# APPLICATION

## SEWAGE DISPOSAL TESTING

HOWARD COUNTY HEALTH DEPARTMENT  
ENVIRONMENTAL HEALTH SERVICES

**REVISED**  
**PERC CERTIFICATION PLAN**  
LOT 26  
ROVER MILL ESTATES

Lot  
26

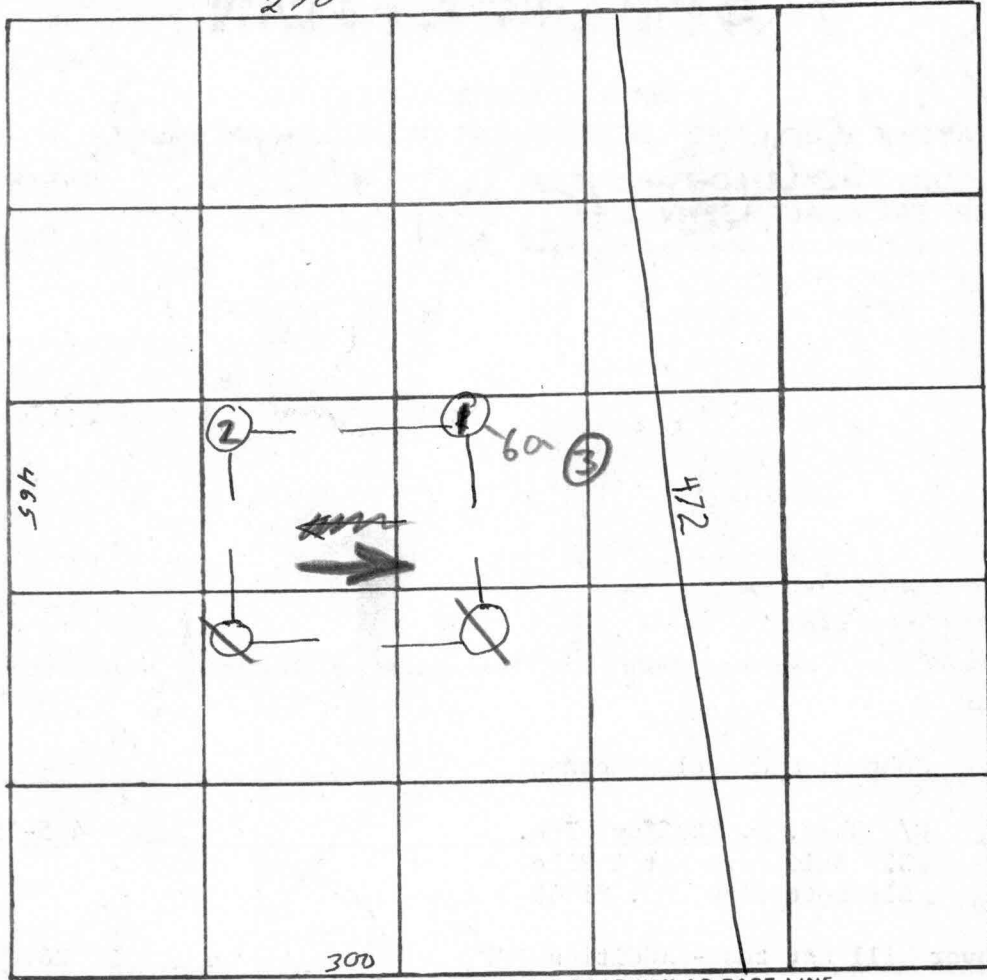
REJECTED BY R. Monfield FOR any DATE 4/28/76  
(KIND OF SYSTEM)

REASONS FOR REJECTION OR HOLDING deep clay + water

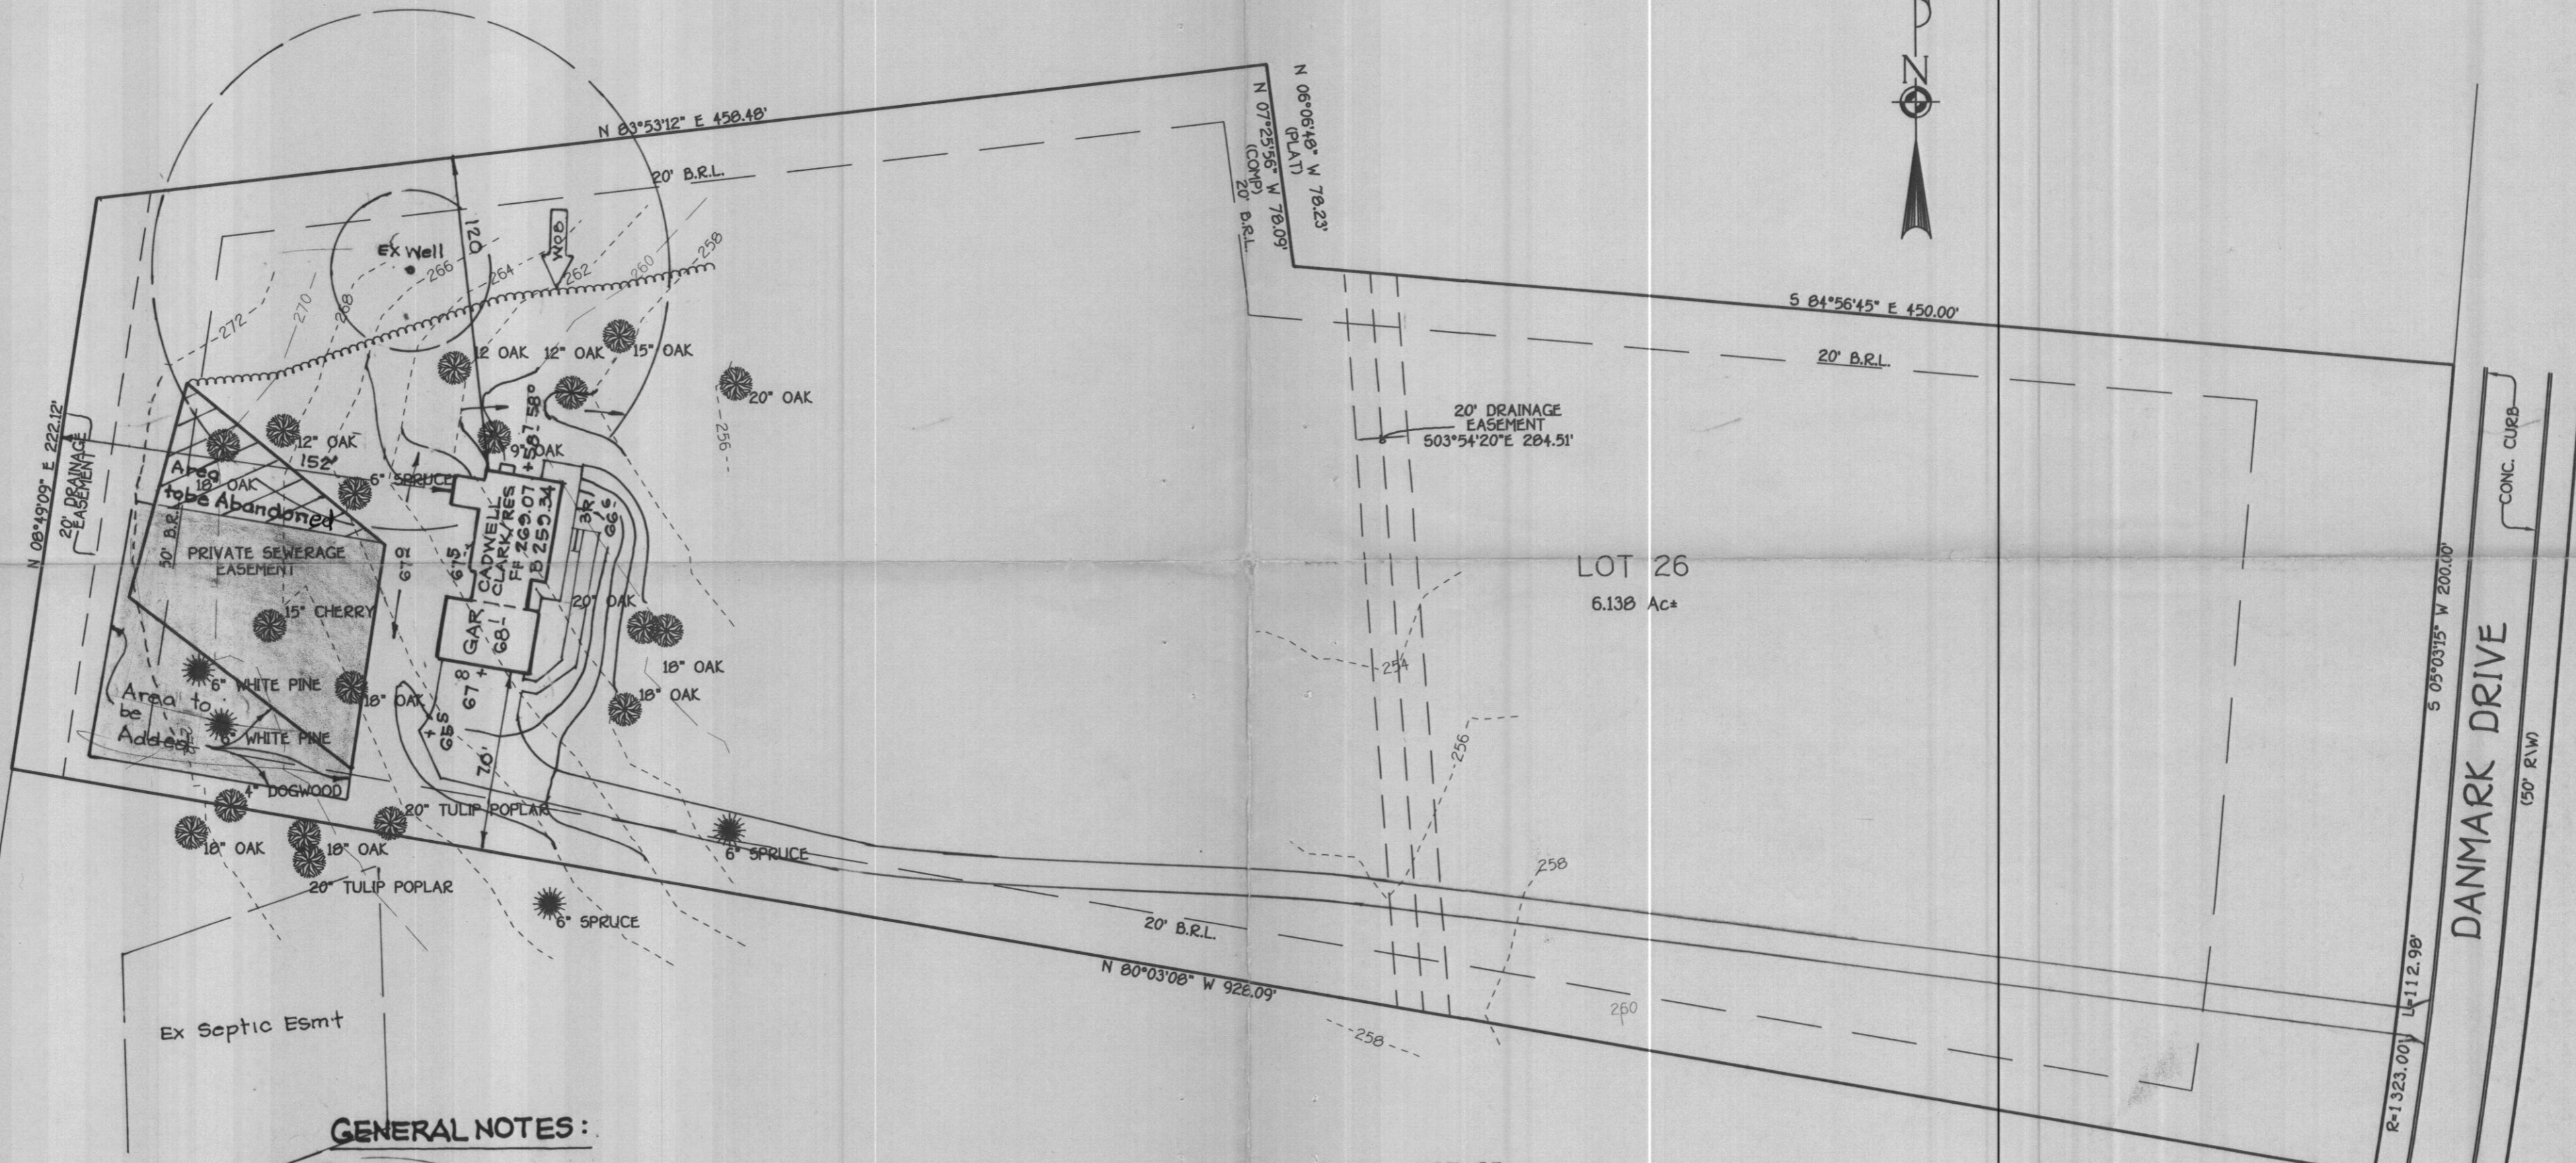
The purpose of this plan is to amend the existing approved septic reserve area. The Howard County Health Dept. accepts this modification to the existing approved septic area.

OK SRN 6/4/01

LOT 26  
COPY OF SIGNED PRELIM  
TOPO NOW IN DWG  
RE-ISP REQ'D?

pool location

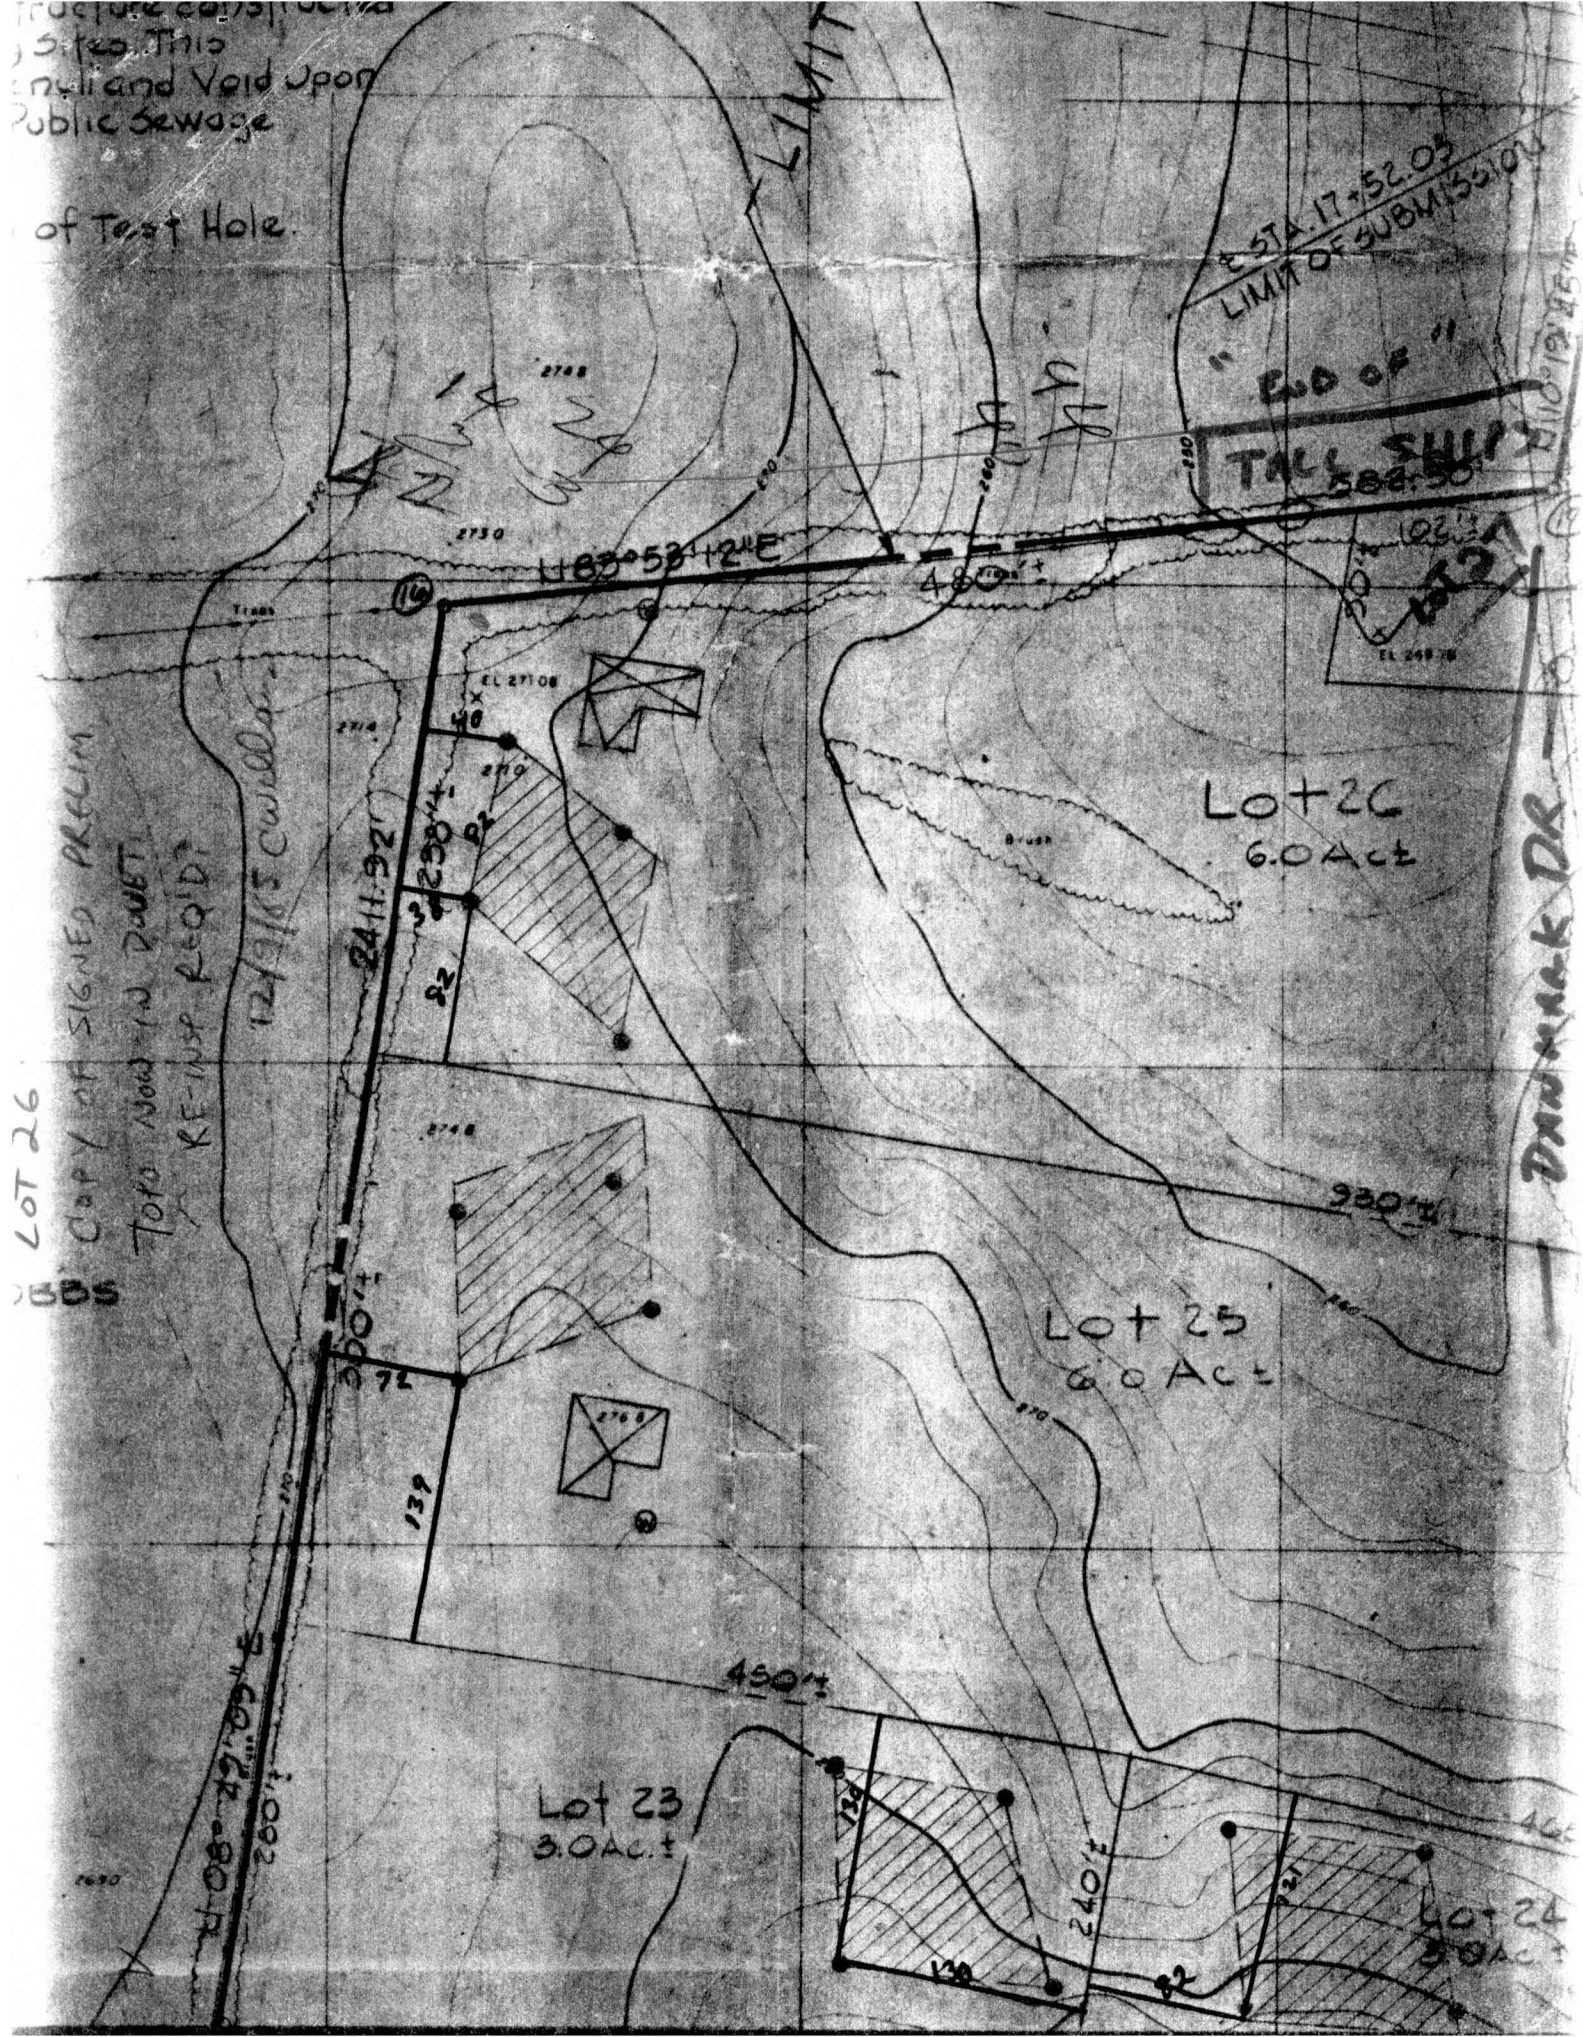
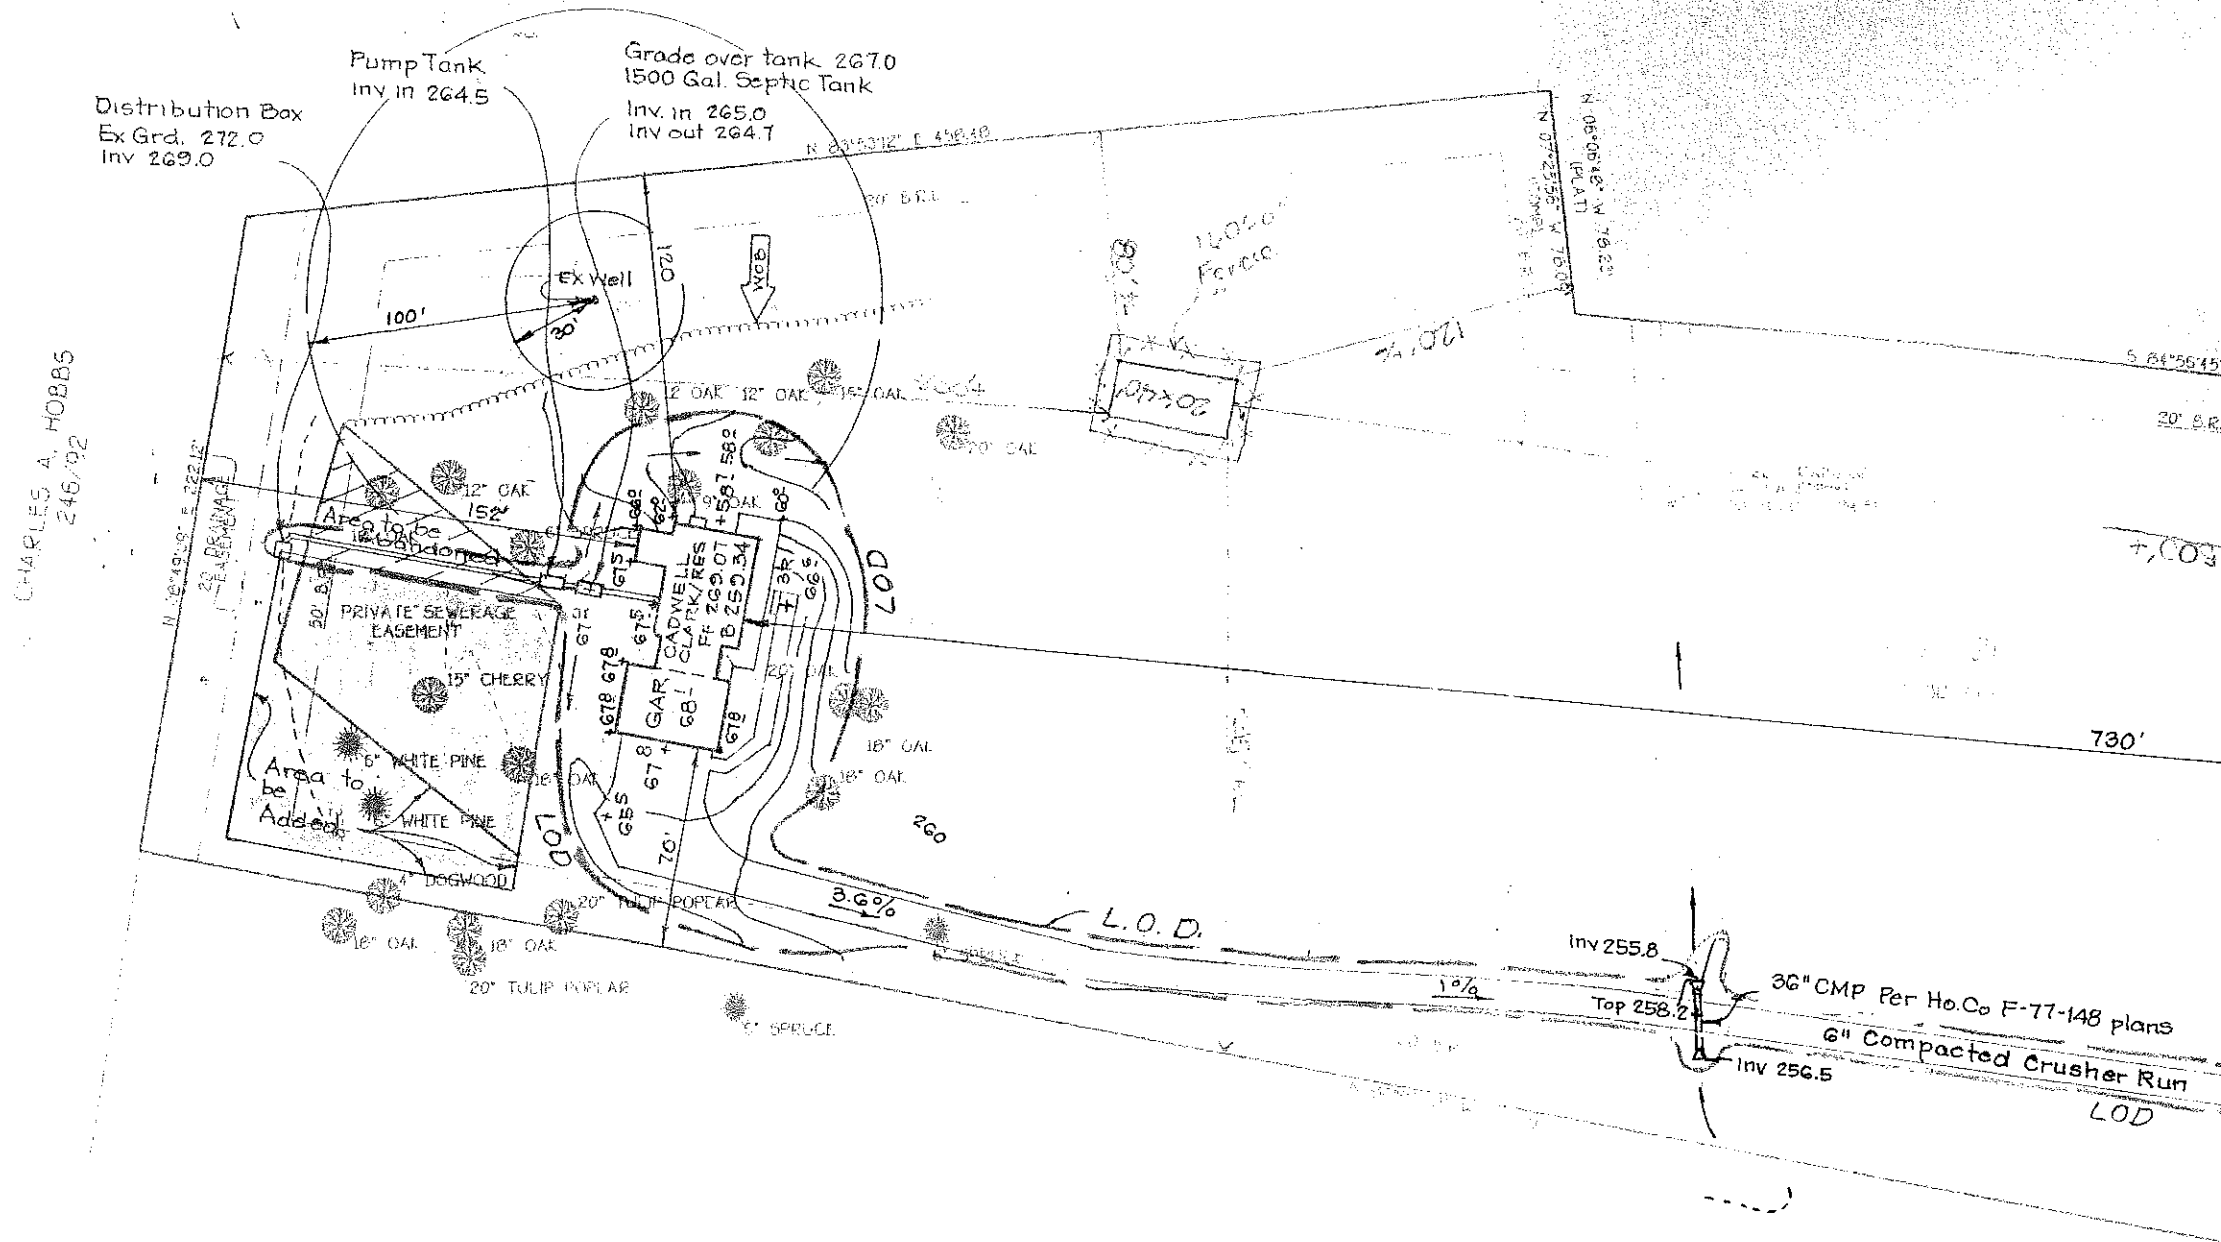
5-28-03

OK
